# IEEE P802.3bt PSE State Diagram Update

Dan Dove, DNS for LTC

*June 16, 2015*

Type 3 and Type 4 PSE Searching (SRCH) State Diagram

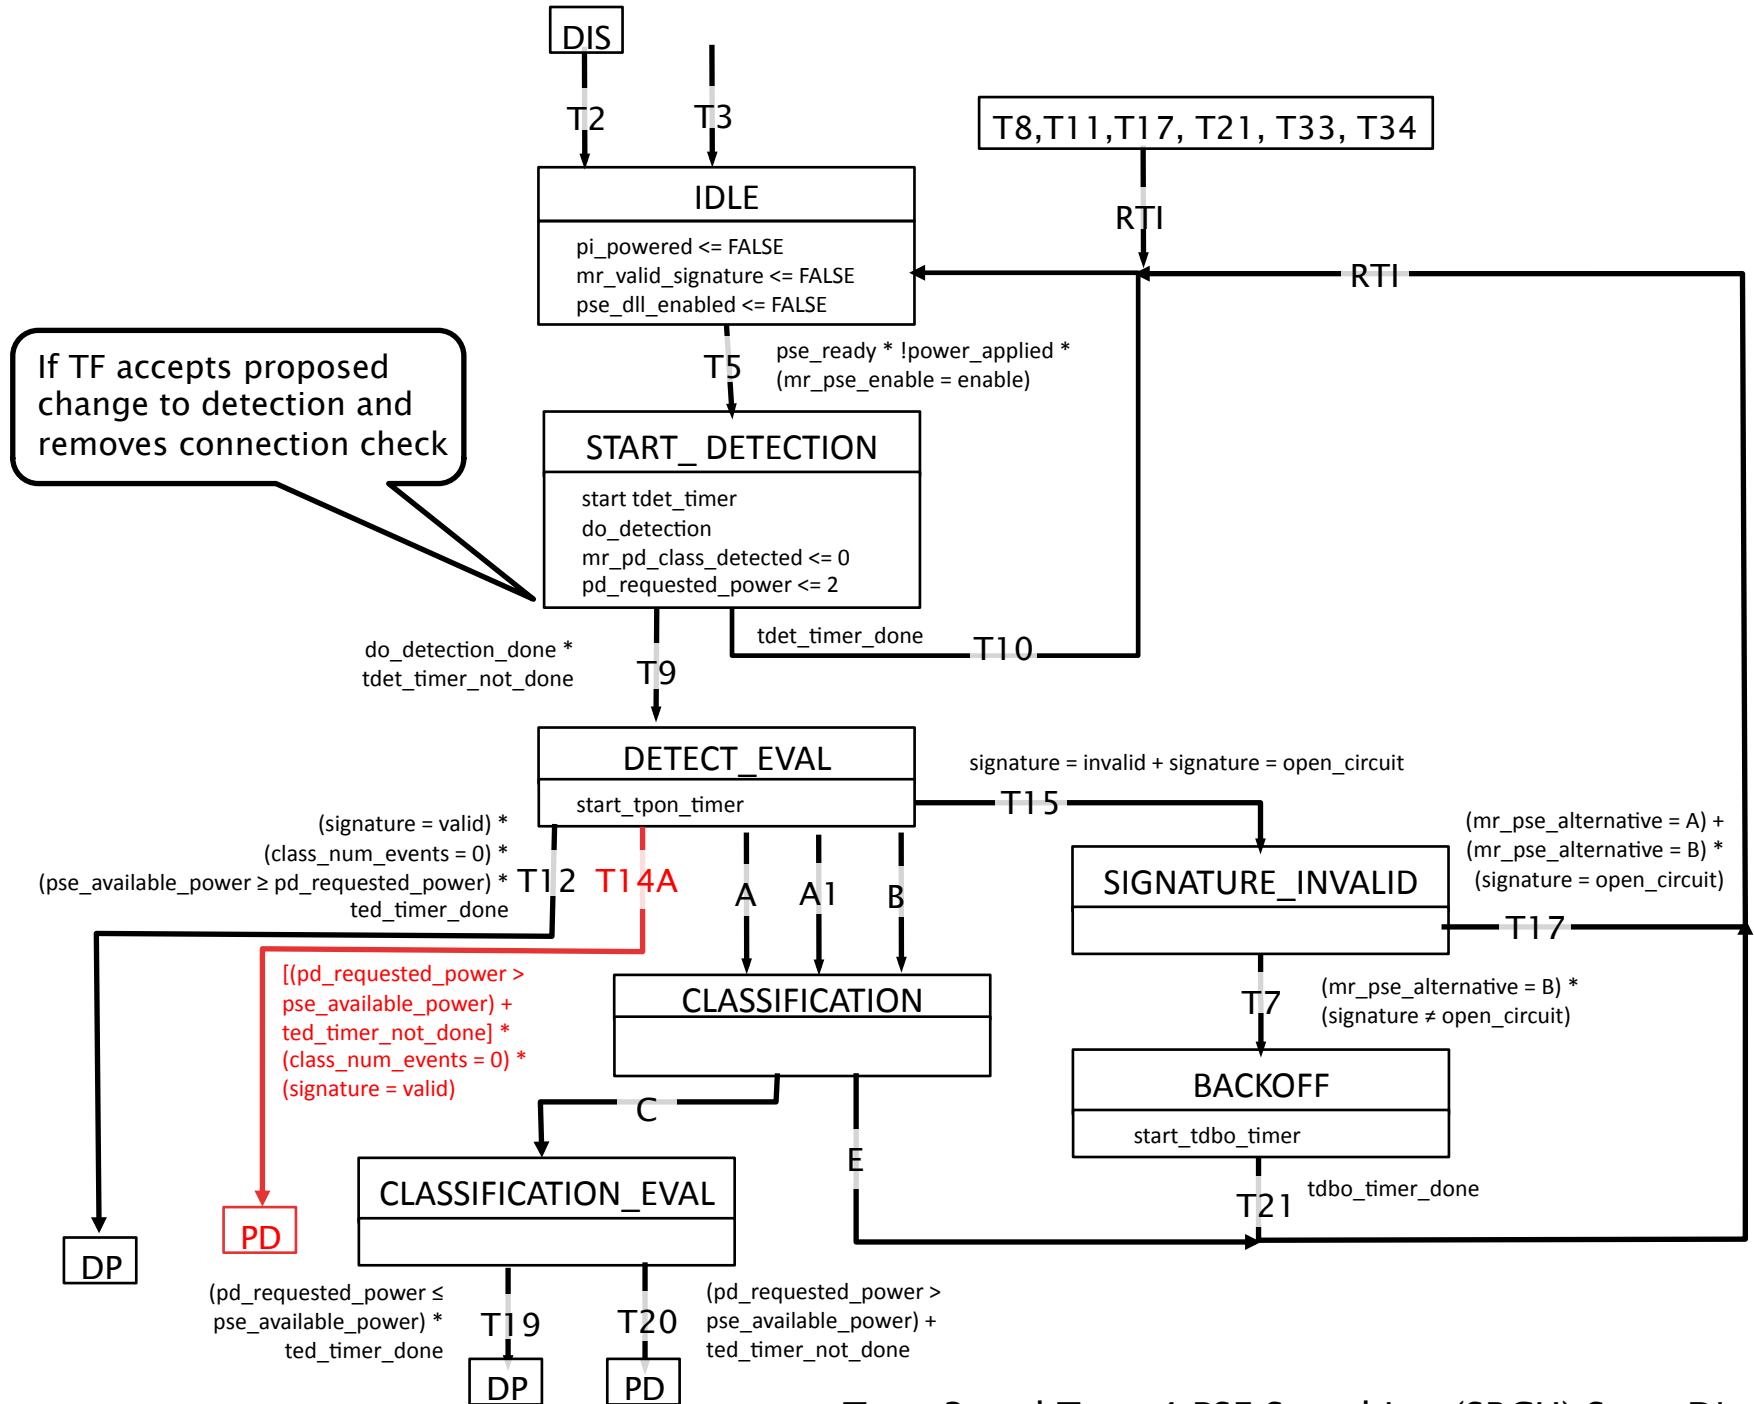
1. Removed slide formatting and borders to make more direct transfer to FrameMaker for editor.
2. Removed diagonal transitions where appropriate
3. Added do\_connection\_check into Searching Diagram
4. Added T14A transition into Searching Diagram
5. Added do\_connection\_done term into transition T9
  - Is it really the best way to address this functional requirement to have do\_detection AND do\_connection\_check when one can logically have only a connection\_check that presents the same logical outcome? (Explained later)

Detection and Connection Check carry a lot of redundancy:

- Both have Invalid and Open Circuit results.
- Both seek to determine whether a valid PD is present
- Neither tells you which ALT the signature is present on.

Proposal – Eliminate Connection Check and Enhance Detection

- Both have Invalid and Open Circuit results.
- We only need to clearly articulate the conditions such that correct interpretation of the results can be achieved.
- Both seek to determine whether a valid PD is requesting power.
- One seeks to find if a PD is requesting power, the other seeks to determine if that PD is requesting power on one alternative, or both.

do\_detection

This function returns the following variables (see 33.2.5):

signature:

This variable indicates the presence or absence of a PD and whether it has a single or dual signature.

Values:

open\_circuit: The PSE has detected an open circuit on all pair sets tested. This value is optionally returned by a PSE performing detection using only Alternative B.

Alt\_A\_valid: The PSE has detected a dual signature PD requesting power on the Alt\_A pair set.

Alt\_B\_valid: The PSE has detected a dual signature PD requesting power on the Alt\_B pair set.

Alt\_AB\_valid: The PSE has detected a dual signature PD requesting power on both pair sets.

valid: The PSE has detected a PD is requesting power or by Type 3 and 4 PSEs performing detection over both pair sets and determining that a single signature PD is present.

invalid: Neither open\_circuit, nor valid PD detection signature has been found on either pair-set.

Type 3 and Type 4 PSE Searching (SRCH) State Diagram

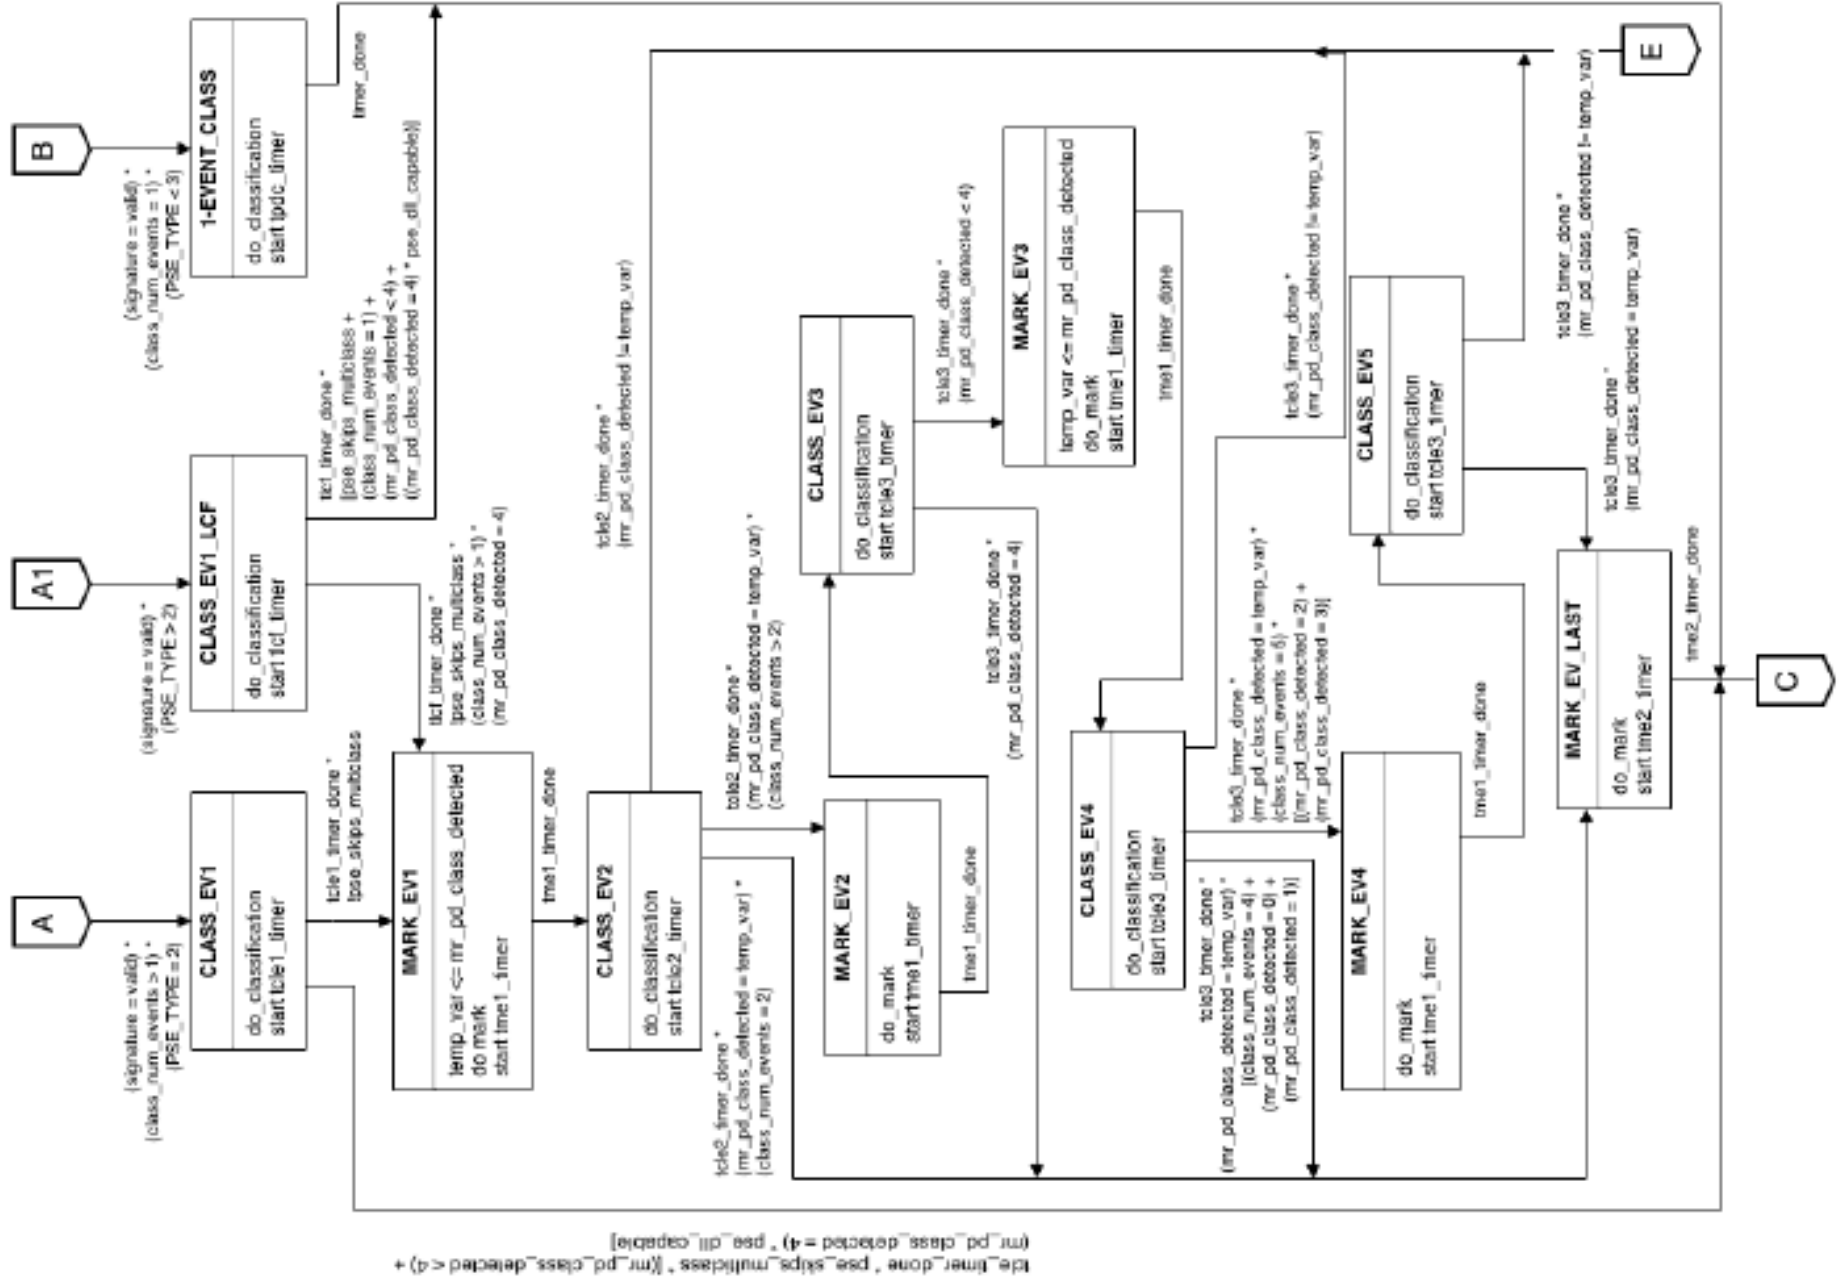
If TF accepts proposed change to detection and removes connection check

Type 3 and Type 4 PSE Classification State Diagram

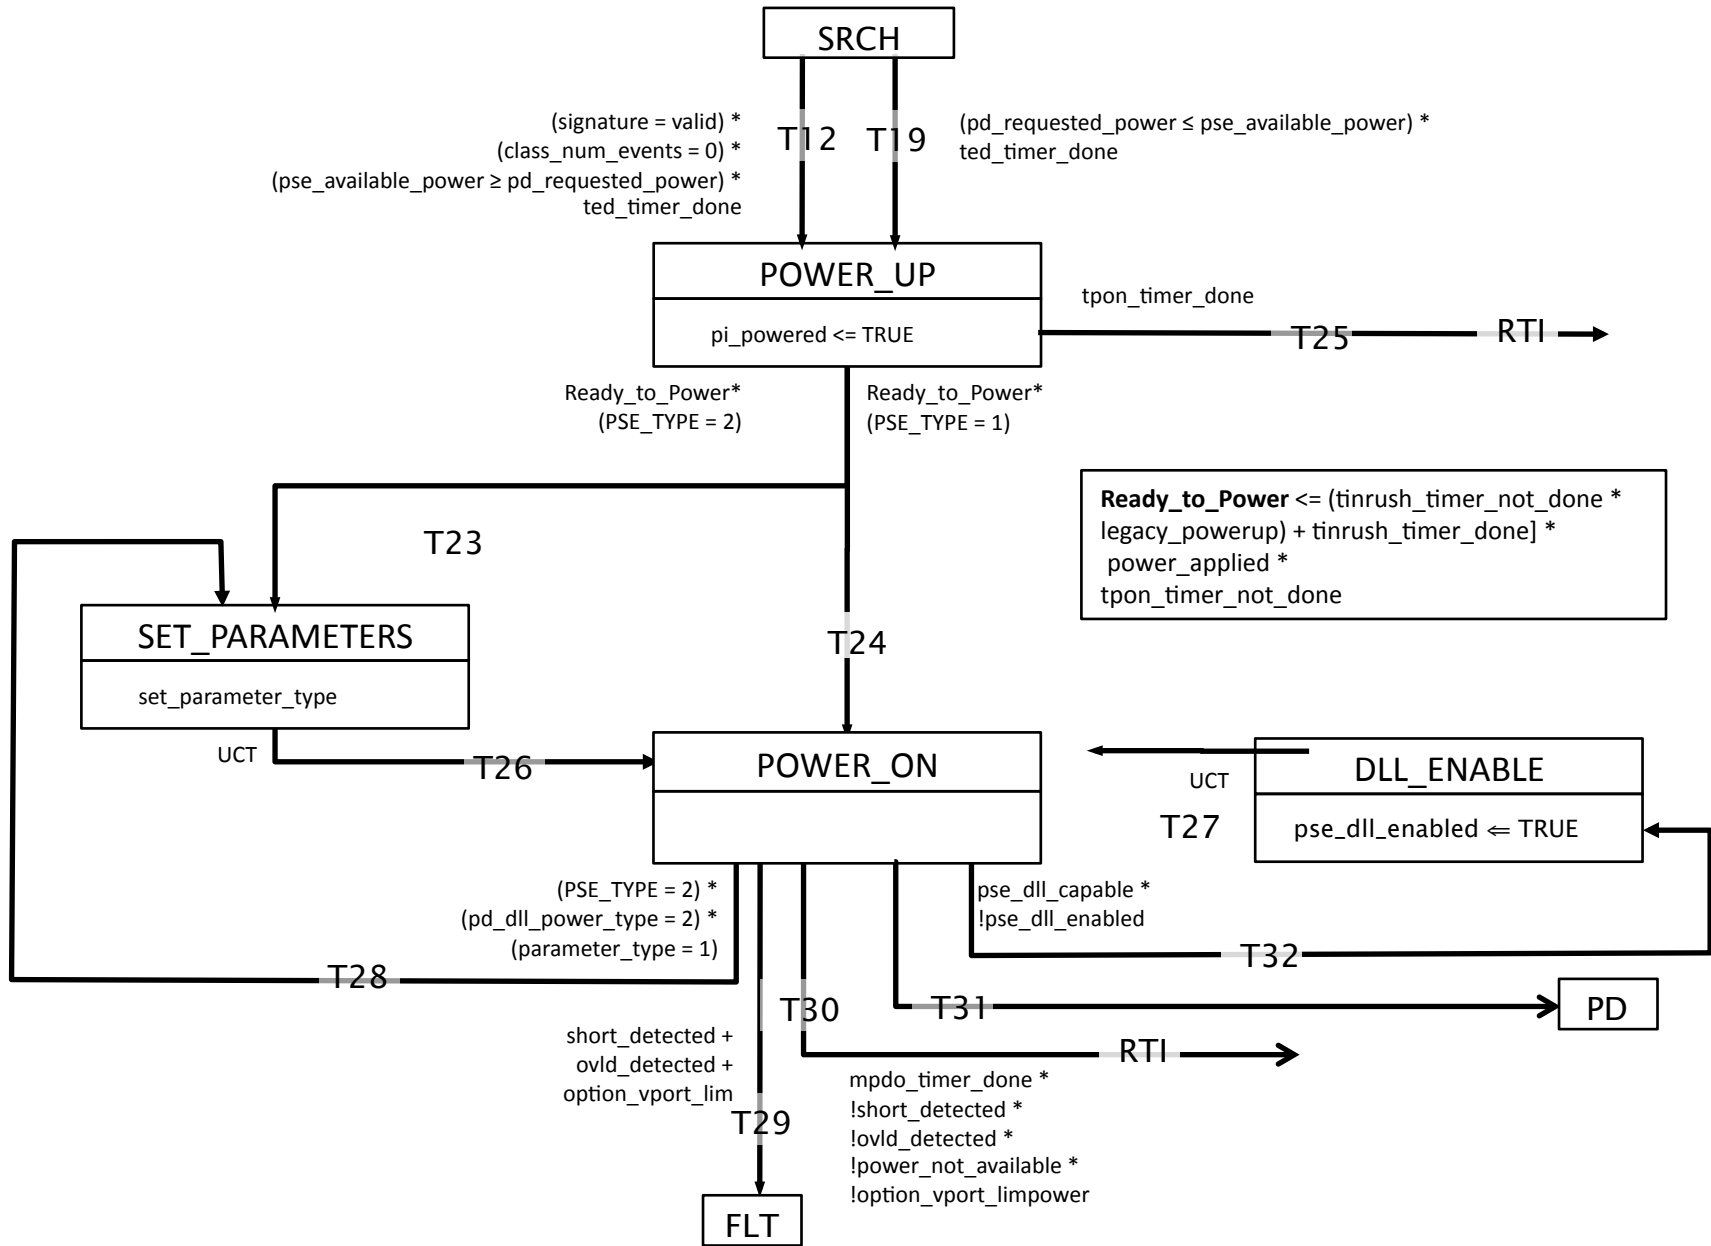
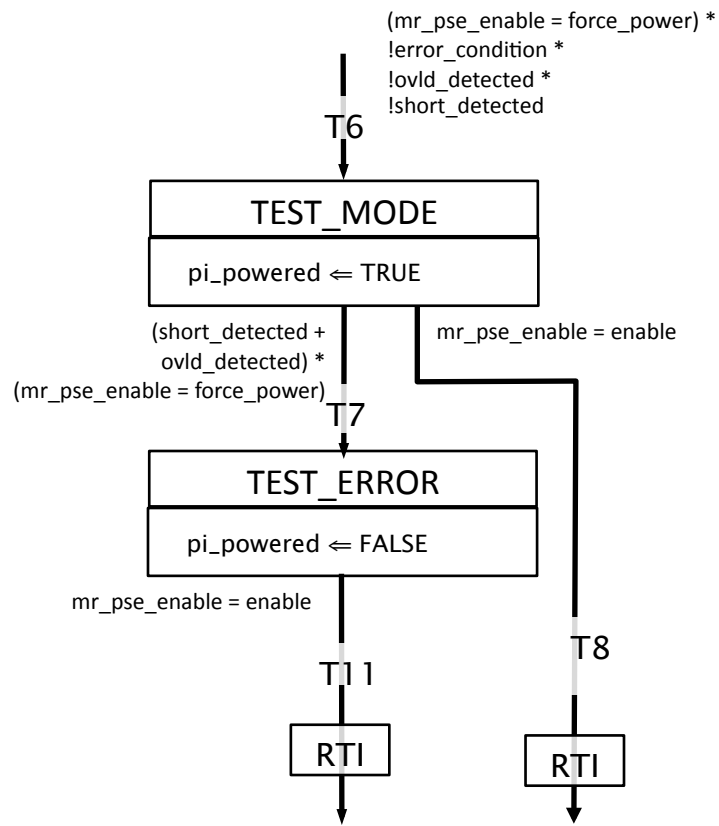
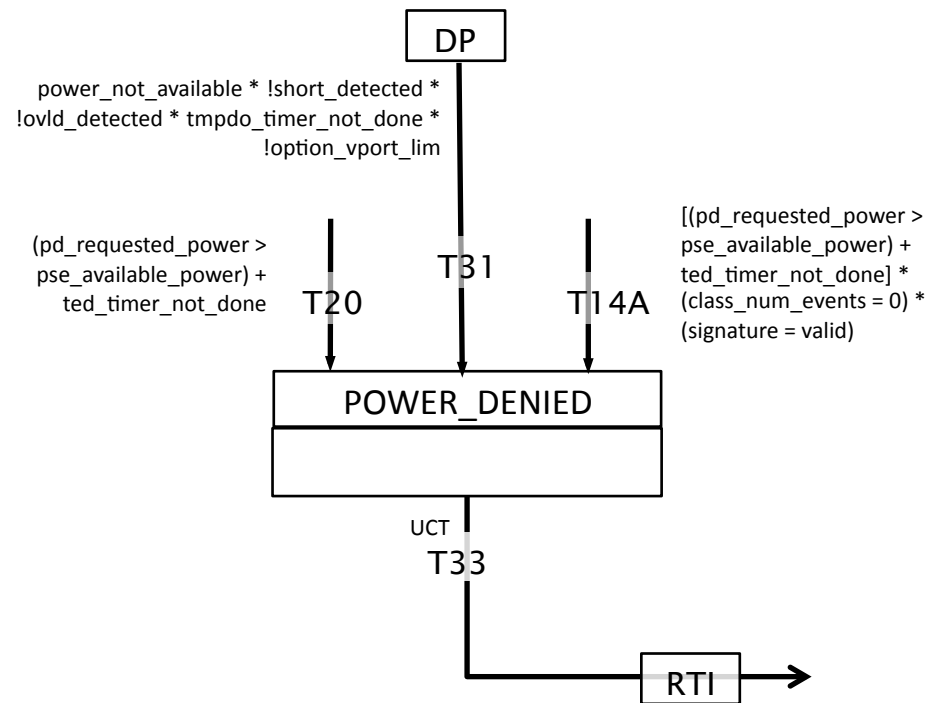
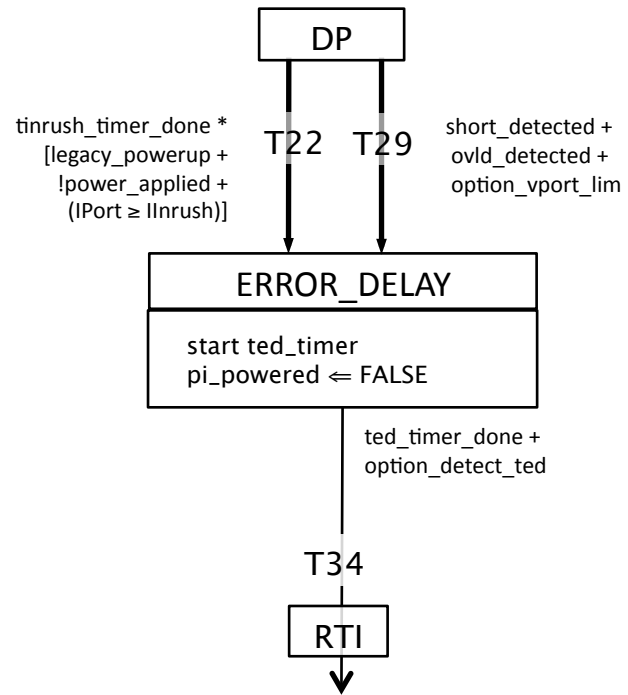
## Issues with the Classification State Diagram:

- Doesn't address how a dual channel PSE classifies each pair set
  1. One entry point into Classification State Diagram
  2. No method shown to classify alt-A versus alt-B

3. This assumes only one classification per PD, and does not provide guidance on which pair set to perform classification.
    - a. We can assume that classification can be done on either pair-set and only do it once and it will total power required by the PD for cases of dual-channel and single-channel PSEs.

- b. We can assume that classification for single signature PDs equals total total PD power and that classification for dual signature PDs must equal half of total PD power on each pair set.

4. OR we must perform classification on both pair sets (for dual-signature PDs) and determine the power for each pair set independently from the other.

- I recommend 3a
- I cannot advise on changes to the PSE and/or Classification State Diagram wrt Classification until these concerns are answered.
